## EMPIRE FLOODGATE

### PERIODIC INSPECTION REPORT NO. 4

SUBJECT: New Orleans to Venice, Louisiana (Hurricane Protection);  
Reach B-1 - Tropical Bend to Fort Jackson, Empire Floodgate,  
Periodic Inspection Report No. 4, 31 January 1984

1. The inclosed periodic inspection report is approved subject to the following comments:

PLATE I-4

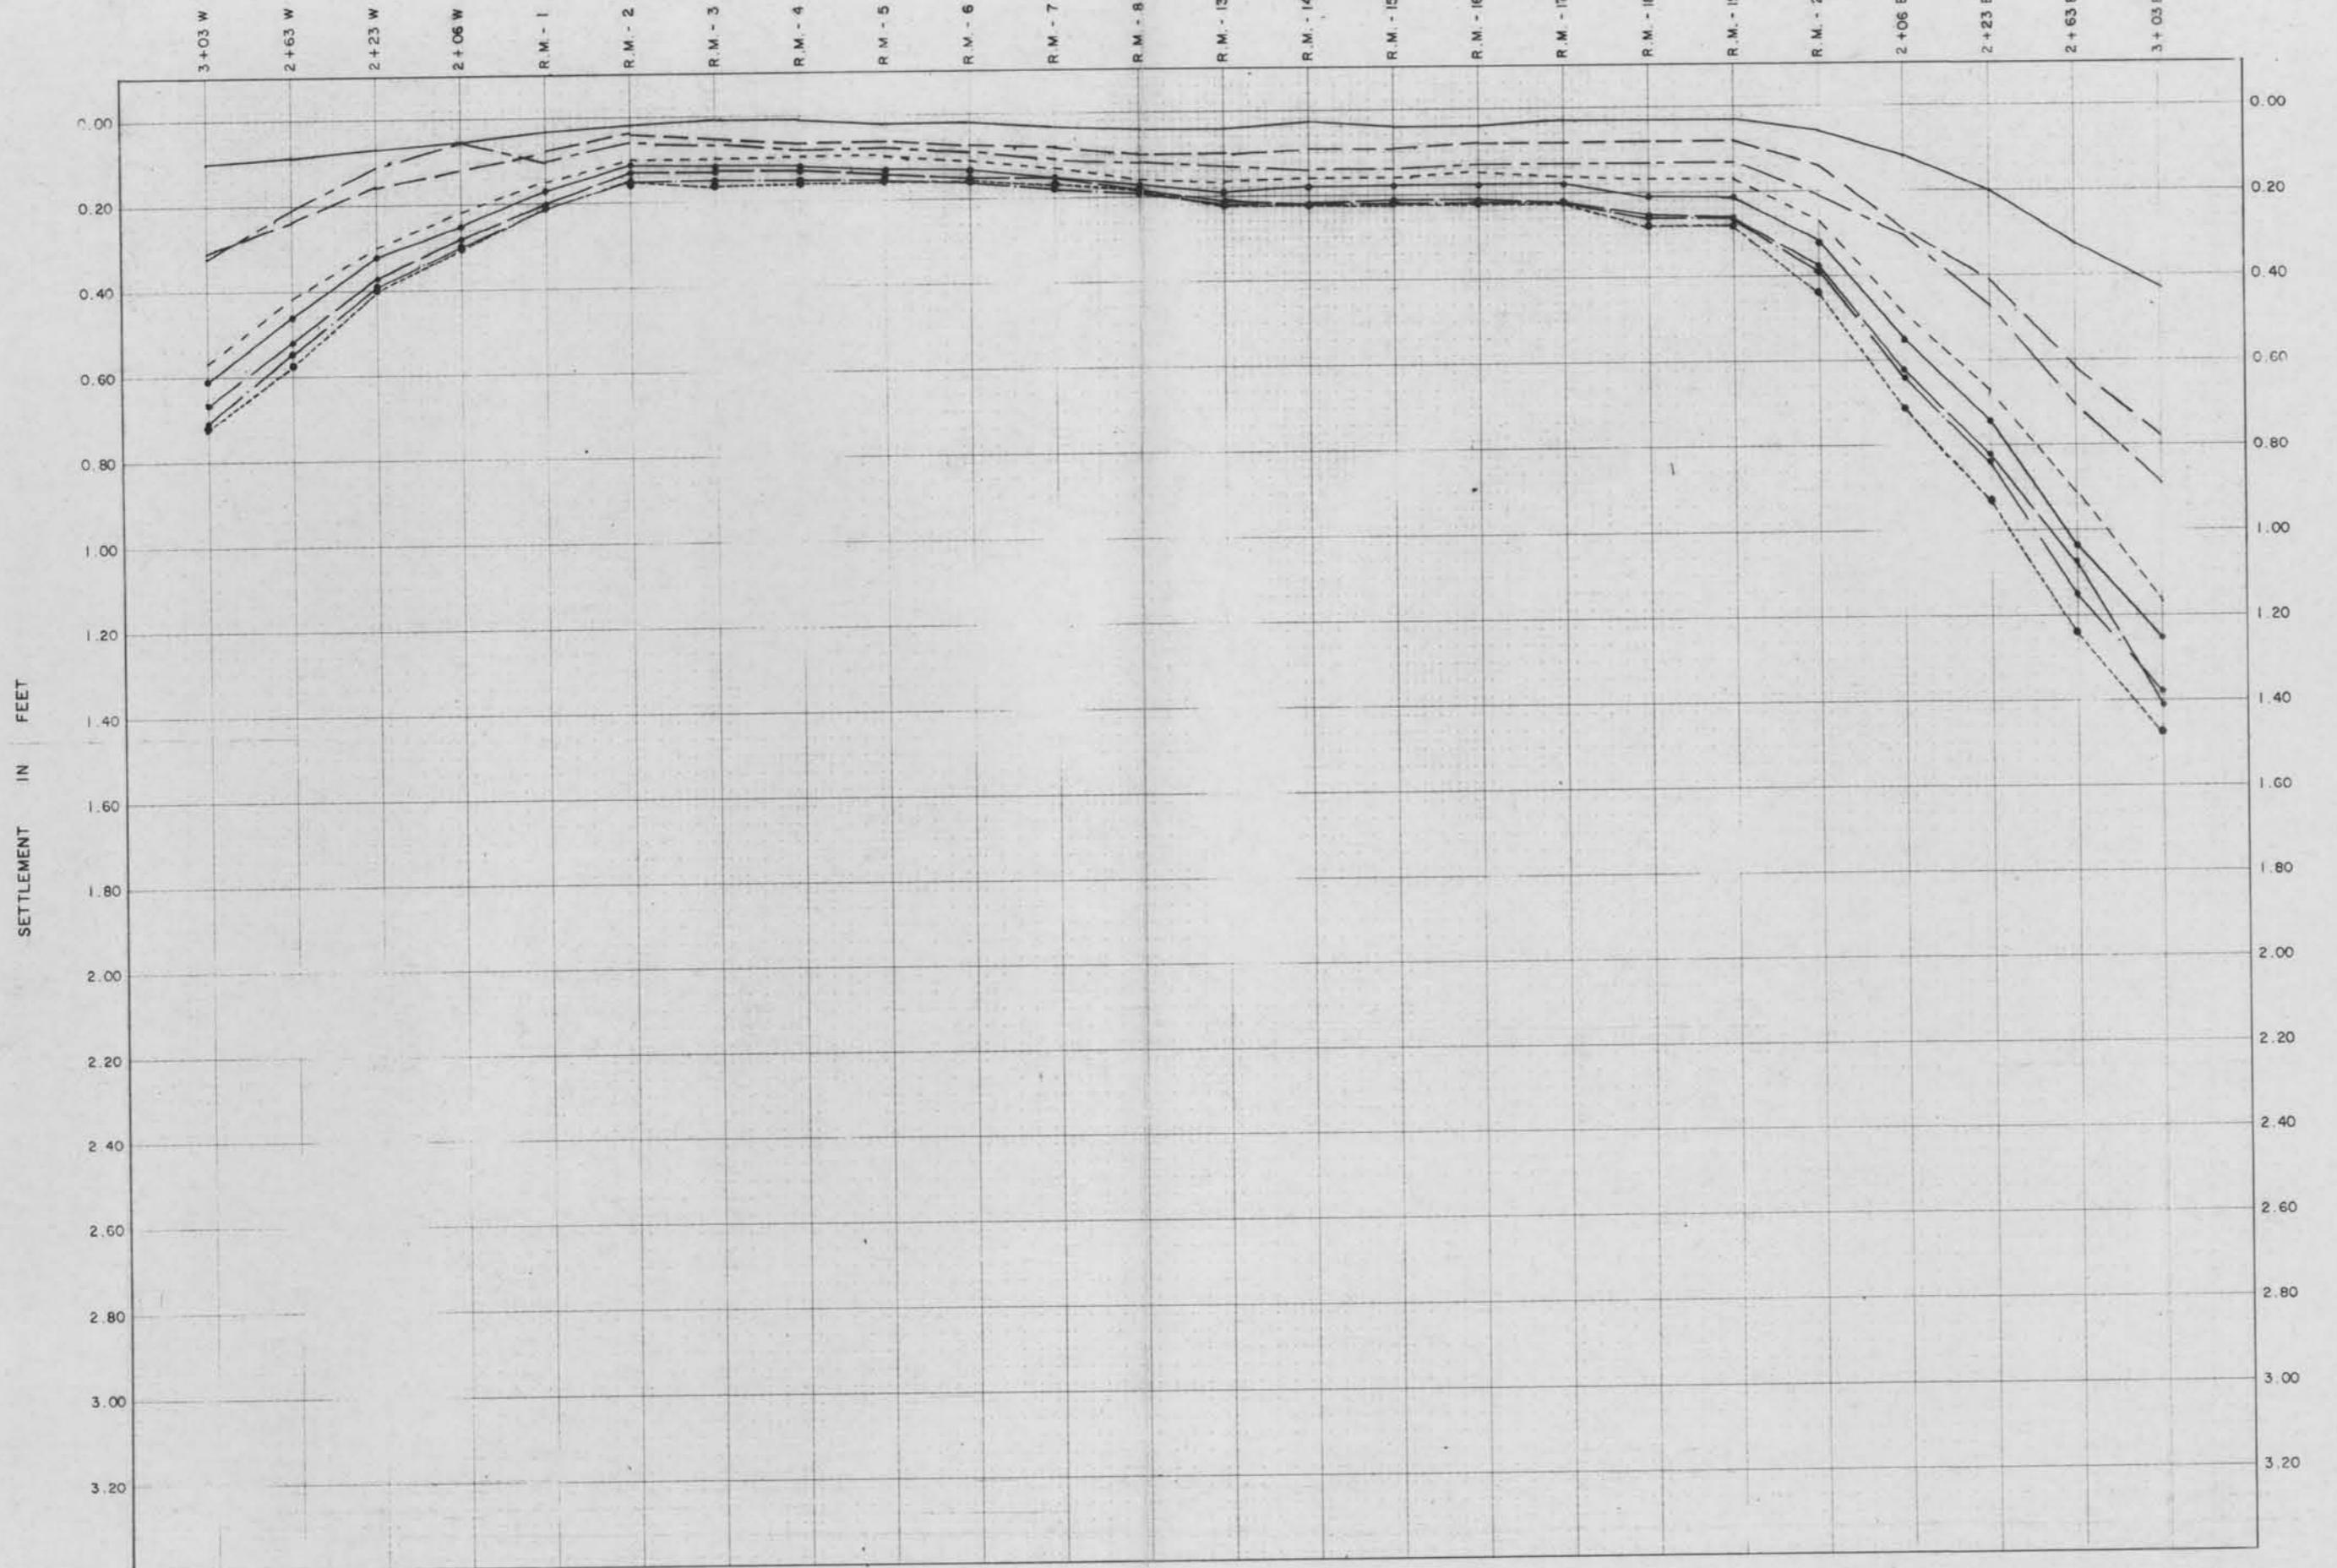
(1) This paragraph should contain a complete discussion on all settlement reference marks. In this regard, the discussion on settlement data for the sheet pile I-walls should be included in this paragraph in lieu of para 5-03.C.1. In the discussion of settlement data for the T-walls, it should be indicated that the settlement data on Plates I-3 and I-4 show that settlement of the T-walls is essentially complete with the exception of settlement mark 20 which indicates that the east end of the east T-wall is continuing to settle.

(2) This report should include time-settlement plots for the I-wall settlement reference marks. Note that this was discussed in para g(2) of the 1st Ind to the LMNED-DG letter of 23 Nov 81 referenced in para 1a above.

(1) Concur. See Inclosure 2.

(2) Concur. Time settlement plots for the I-wall settlement reference marks for 1984 data are being completed by our drafting personnel. They will be distributed to your office upon completion within 45 days.

Para 1b(2). The time settlement plots for the I-wall settlement reference marks for 1984 data are submitted for your files. See Encl 4.

Photo 3: Excessive Gap Between RM 19 and RM **18**

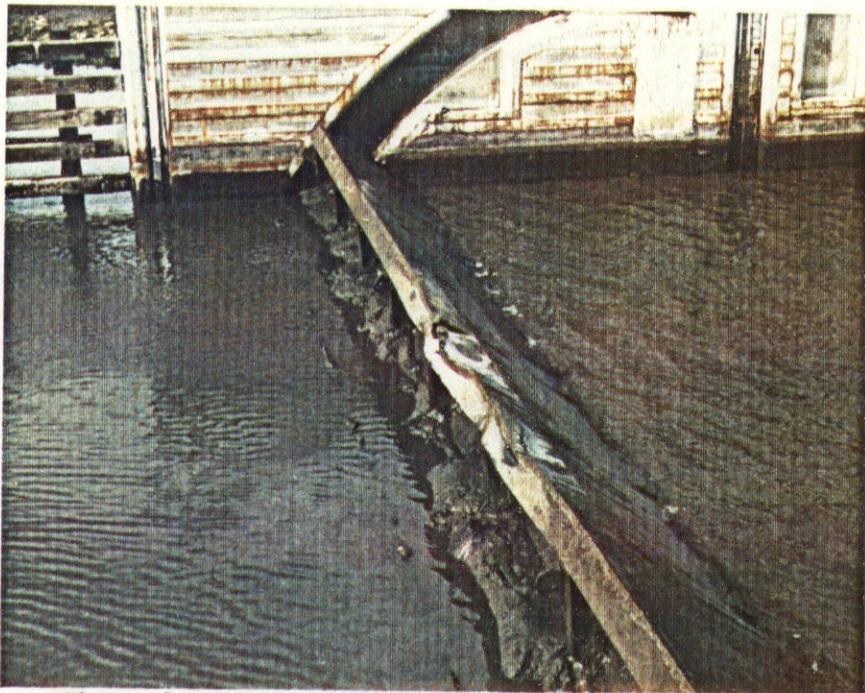
(1) There appears to be a conflict between these two paragraphs. Paragraph 5.03A.1.b indicates that there is no substantial change in recent joint measurements between reference marks RM-18 and RM-19 and concludes that the wall foundation seems to have stabilized. However, paragraph 5-03C.3 indicates that the joint between T-wall monoliths T-4R and T-3R is continuing to widen as seen from the measurement of distances between RM-18 and RM-19. This discrepancy should be reconciled. In this regard, settlement data for RM-20 indicate that the east end of monolith T-4R is continuing to settle, as discussed in para 1b above, therefore, the joint between monolith T-4R and T-3R will likely continue to widen until settlement is complete.

(2) These paragraphs should discuss the condition of the waterstop at the joint between monoliths T-4R and T-3R. If the waterstop is ruptured or if it becomes ruptured due to increased widening of the joint, this joint will have to be resealed.

(1) Reference to RM-18 and RM-19 has been deleted in paragraph 5-03A.1.b. Inclosure 3.

(2) The waterstop at the joint between monoliths T-4R and T-3R was in good condition at the time of inspection. If it becomes ruptured due to increased widening of the joint, this joint will be resealed as indicated. See Inclosures 2 and 3.
